NOTICE OF DECISION

TAX LOT: 2S128D001100
CASE NO: 2020-001 SP, CUP, VAR, SUB
DATE OF NOTICE: June 15, 2020

T-S Corporate Park
LU 2020-001 SP, CUP, VAR, SUB

Proposal: The applicant proposes to construct five industrial buildings, approximately 535,000 square feet, for future warehousing and industrial uses. The property will be subdivided into five lots and five tracts and includes the construction of SW Cipole Place. The site is zoned Employment Industrial (EI) and the EI has restrictions which limit the size of standalone warehousing and distribution uses to 150,000 square feet unless a Conditional Use Permit is obtained, this application requests a Conditional Use Permit to authorize Building C to have an area of 183,292 square feet. The project also requests a variance to the Sherwood Zoning and Community Development Code Section 16.106.040.E.1 to allow a cul-de-sac over 200 feet long.

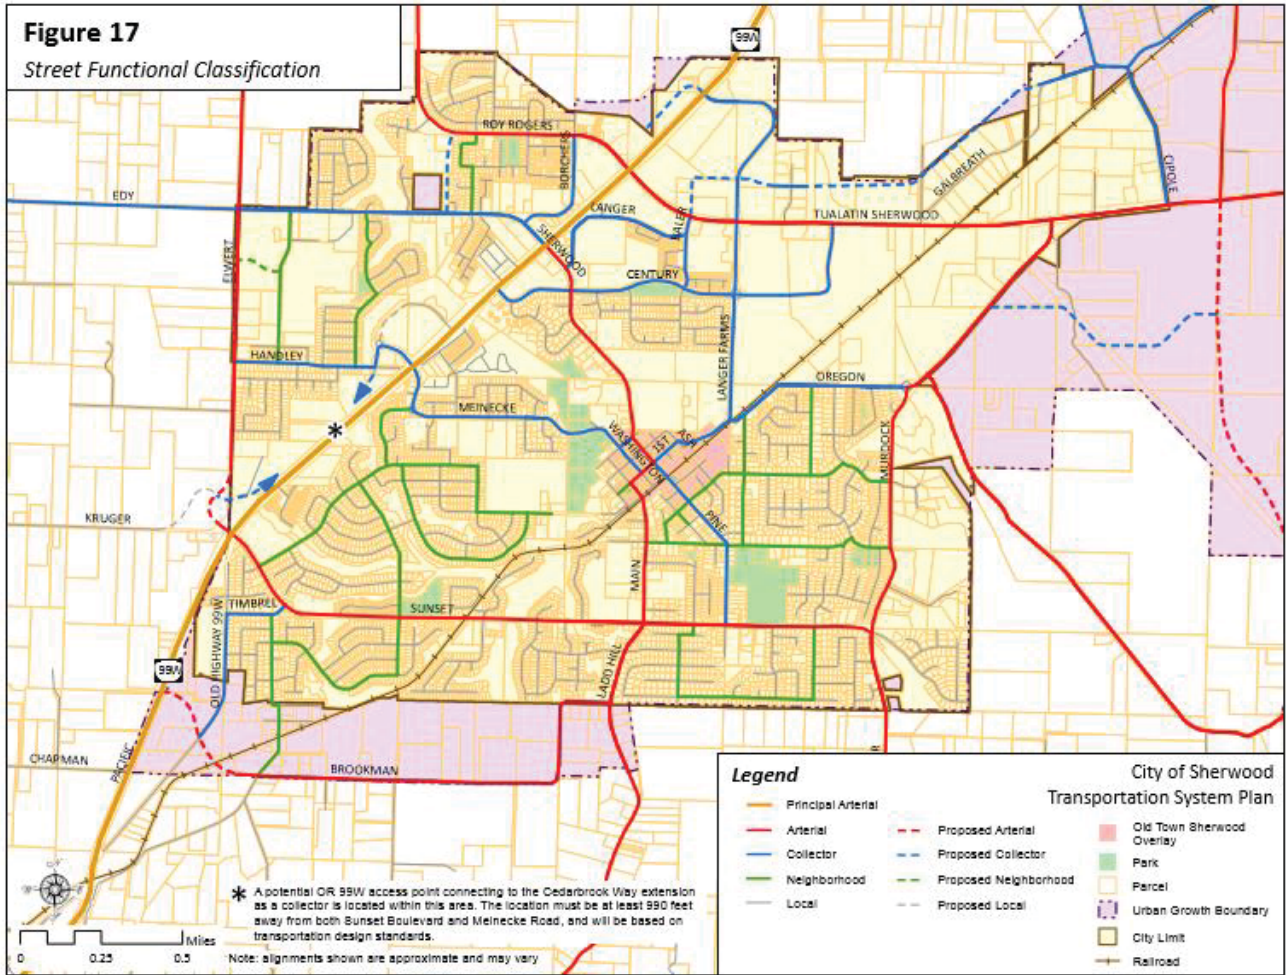
ANALYSIS: SW Tualatin-Sherwood Road and SW 124th Avenue are both Arterial streets requiring a 15-foot-wide landscaped visual corridor along their frontages. The preliminary landscape plans show a 15-foot-wide landscaped visual corridor abutting both roadways within the boundaries of the site.

The southern boundary of the site is the future SW Blake Street which is classified as a Collector roadway based on Figure 17 of the Transportation System Plan.

SEE SHEET
C3.0 FOR
LOCATIONS OF
HYDRANTS

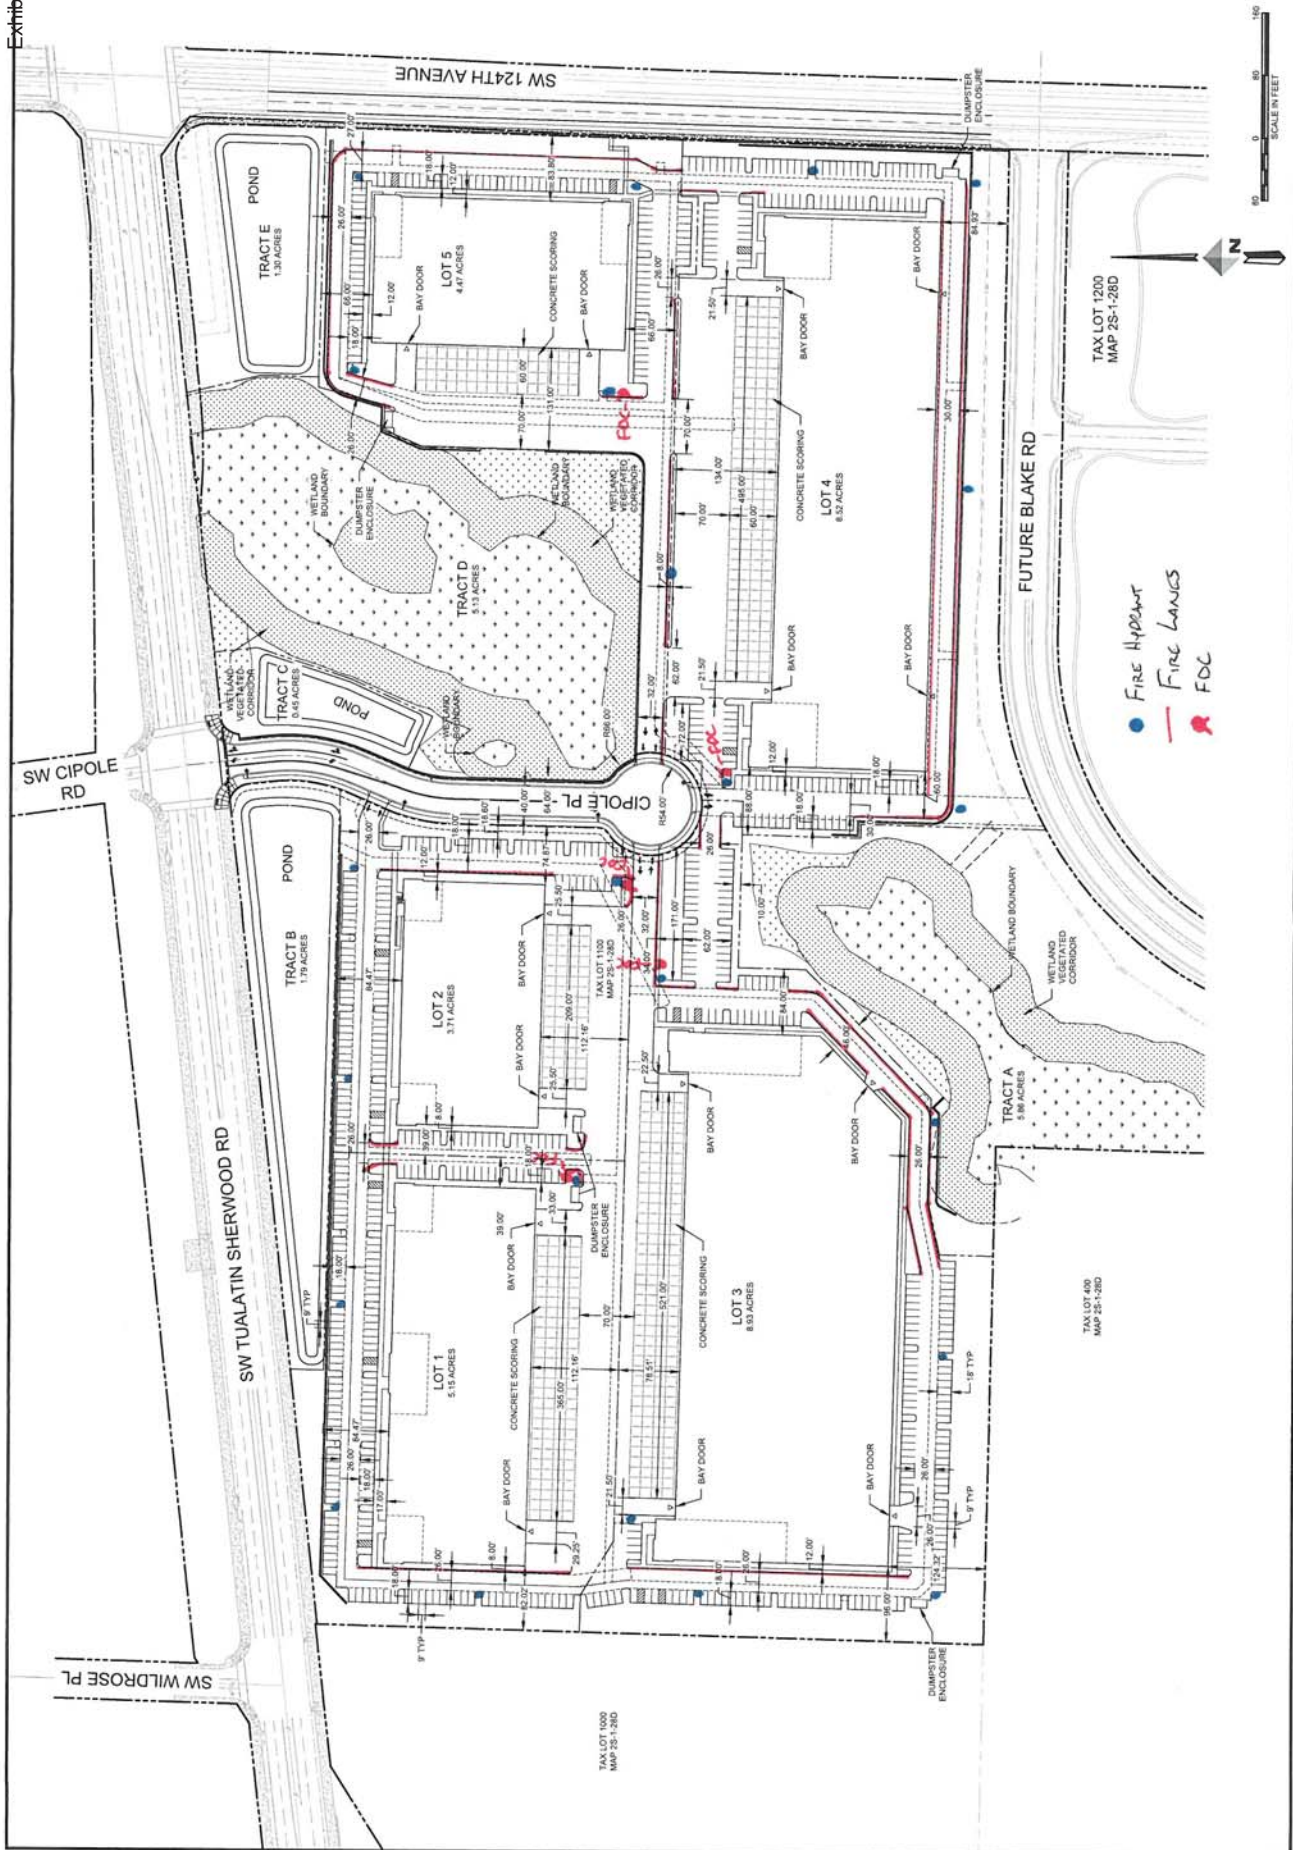
See attached Sheet C3.0 for locations of fire hydrants. Underground private fire line will be reviewed and inspected by TVFR. Ensure no PIV's are proposed in the private line.

See attached Sheet C3.0 for locations of FDC's

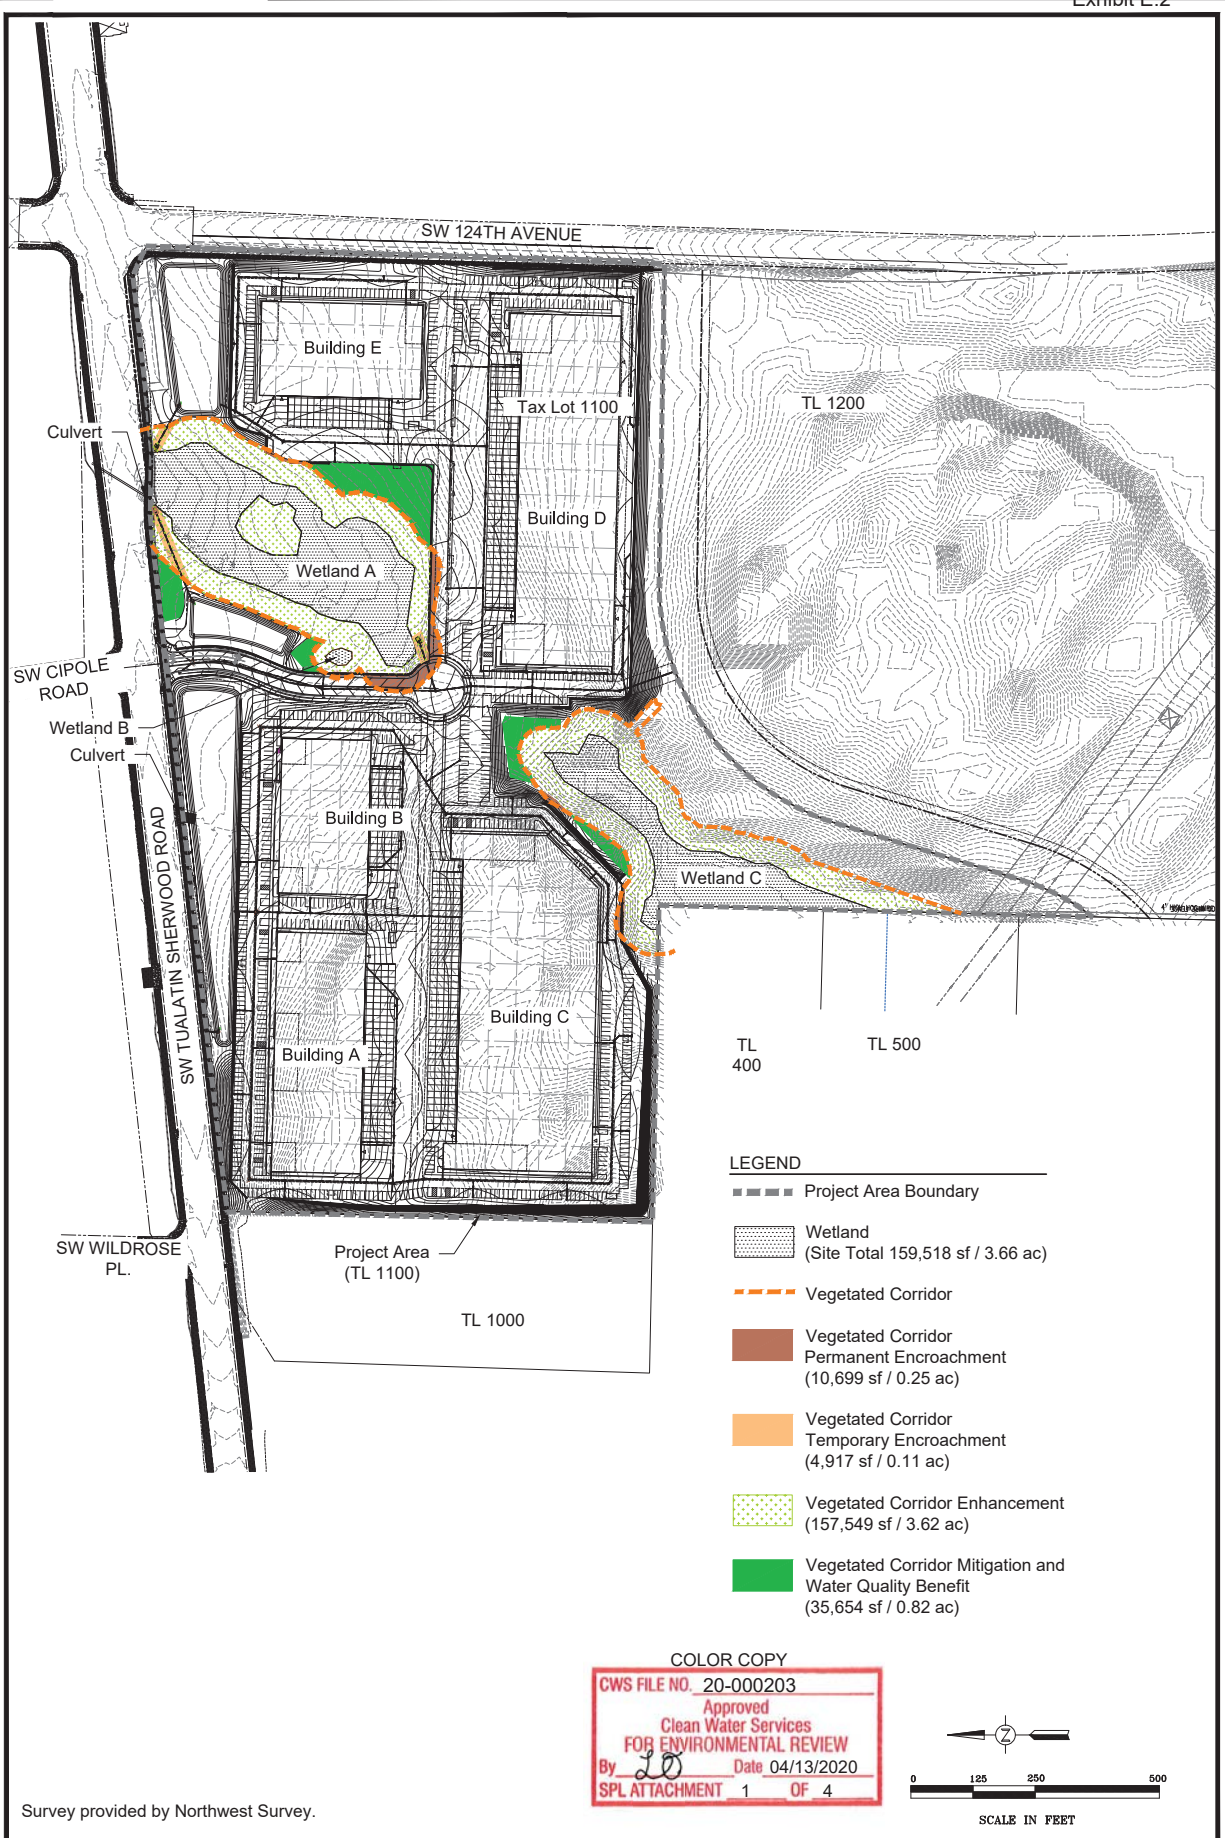
24. **Final construction plans shall clearly depict the location and dimensions of the sensitive area and the Vegetated Corridor** (indicating good, marginal, or degraded condition). Sensitive area boundaries shall be marked in the field.

25. Protection of the Vegetated Corridors and associated sensitive areas shall be provided by the installation of permanent fencing and signage between the development and the outer limits of the Vegetated Corridors. **Fencing and signage details to be included on final construction plans.**
